Alaska District
U.S. Army Corps of Engineers

Public Notice

Date OCT 03 2007 Identification No. ER-07-27
Please refer to the identification number when replying.

Revised Section 117 Expedited Erosion Control Project Kivalina, Alaska

Figure 2. Revised Kivalina erosion control structure footprint, September 28, 2007.

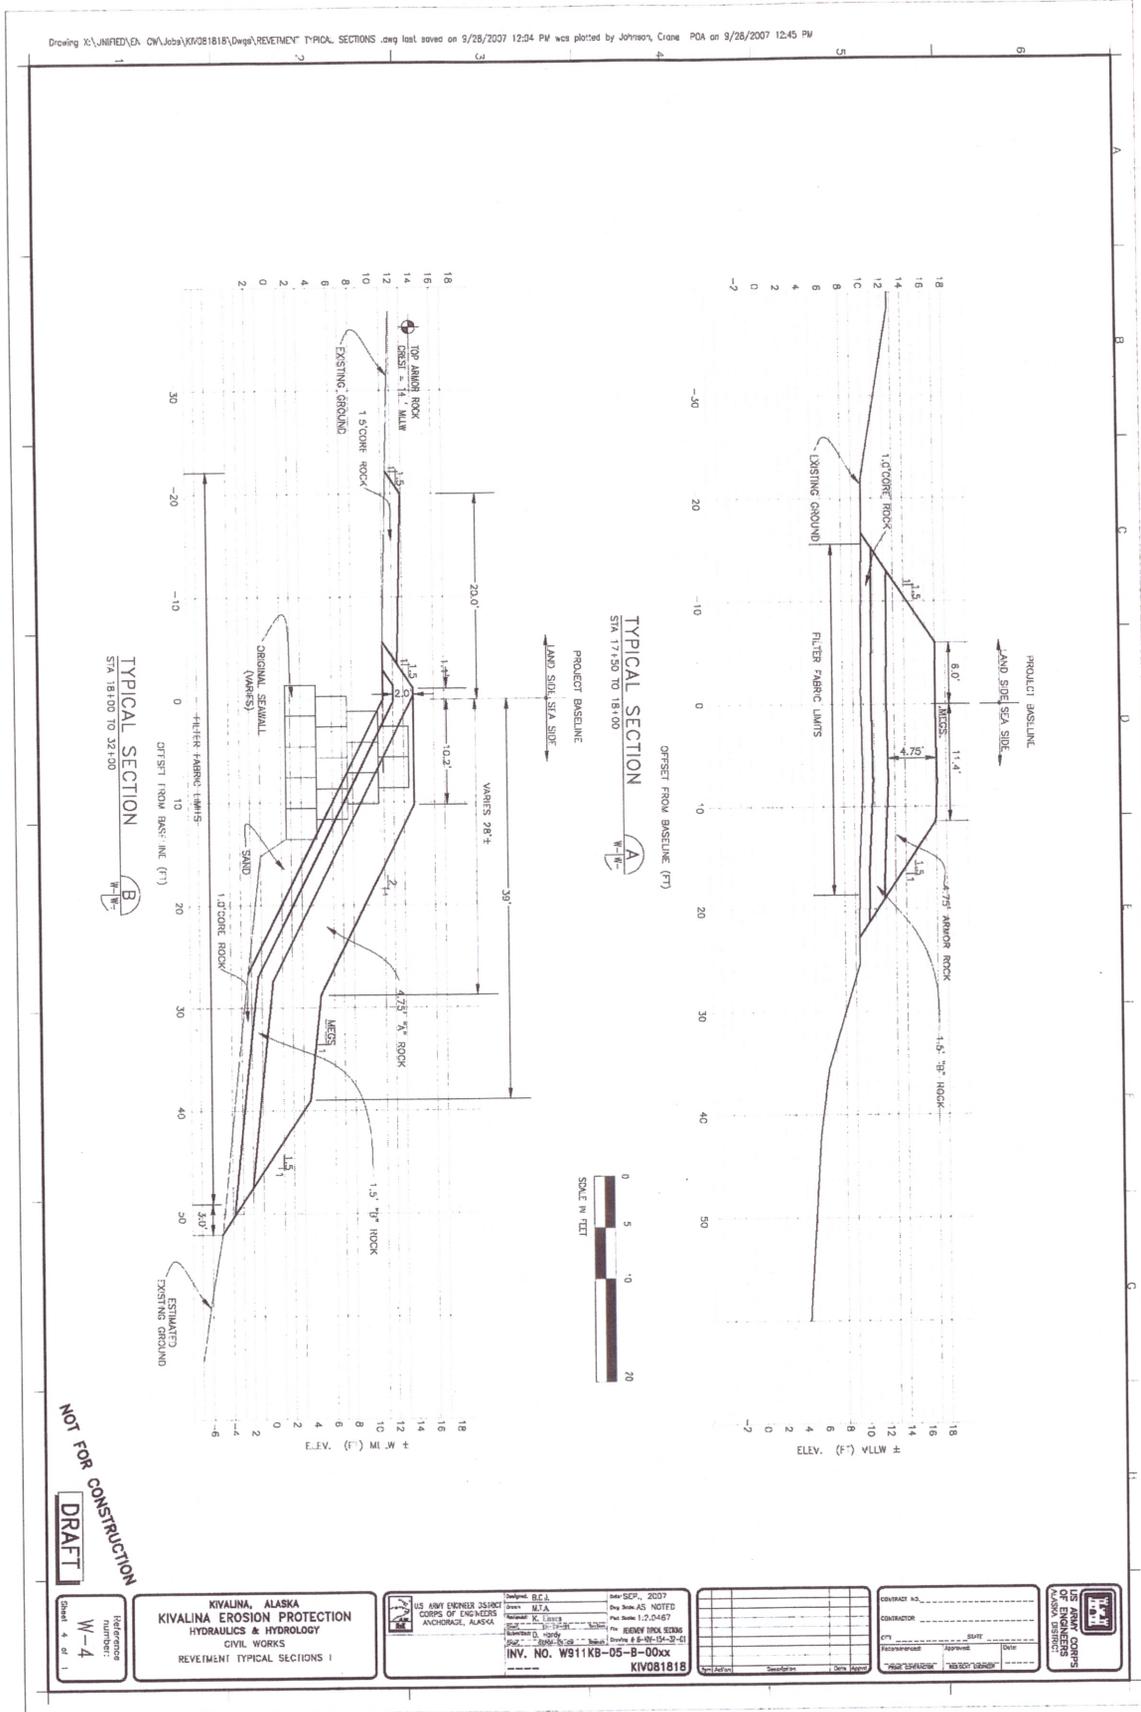
The modifications include length, depth, and slope changes to the revetment proposed on both the Chukchi Sea and lagoon sides of the island. The overall length of the proposed revetment along the Chukchi Sea side of the island has been increased from 3,100 feet to 3,438 feet (figure 2) to prevent flanking, and the toe has been deepened by about 3 feet to compensate for recent scour in front of the existing seawall. The crest elevation of the revised revetment would not change, but the general slope of the revetment on both sides of the island would be changed from 1 vertical (V):3 horizontal (H) to 1V:2H, with the lower portions terminating with a 1V:1.5H slope. Cut and fill would generally be used to create a 1V:2H prepared slope on the Chukchi Sea side. The areas to be cut include portions of the existing seawall and areas seaward of the existing seawall. These areas were disturbed during construction of the original seawall. On the lagoon-side revetment, fill would be used to construct the 1V:2H prepared slope. Larger armor stone would be used to construct the steepened slope. The revised footprint of the revetment would decrease from an estimated 5.7 acres to 5.23 acres due to the change in slope. Revised revetment cross sections are shown in figures 3 and 4.

Figure 5. Revised Chukchi Sea potential sand and gravel source, September 28, 2007.

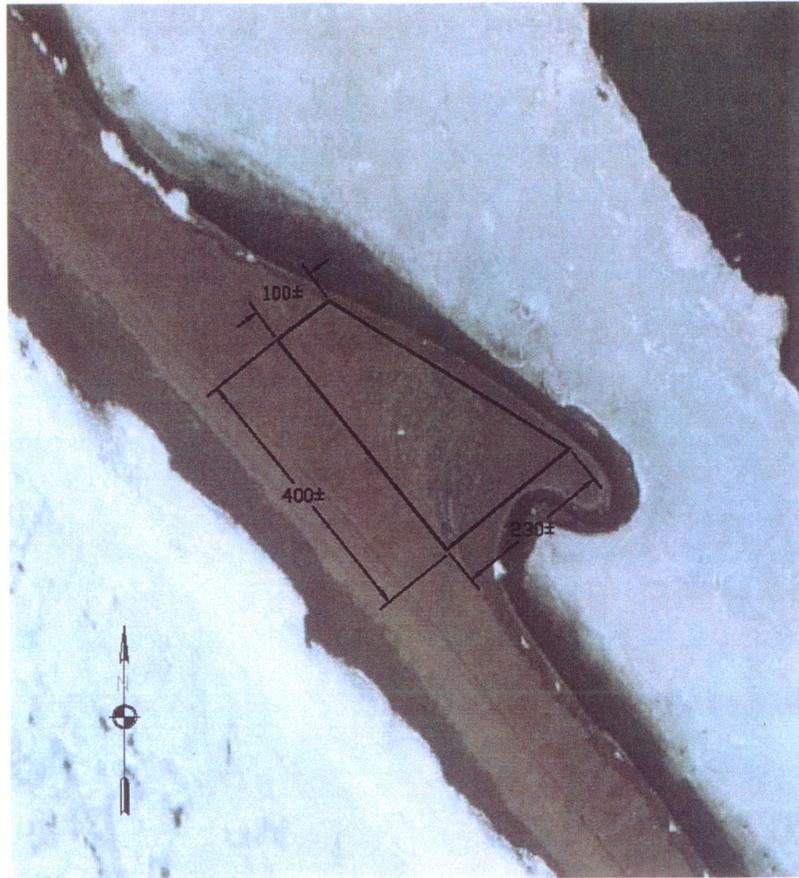
The beach site 1 mile south of Kivalina was also expanded in length from 700 feet to 2,700 feet to accommodate taking the entire estimated 15,000 cubic yards at one time if necessary (figure 5). Expanding the length was necessary to retain reasonable width and depth dimensions. The width and depth of the potential excavation is unchanged from a maximum width of 100 feet and a maximum depth of 18 inches.
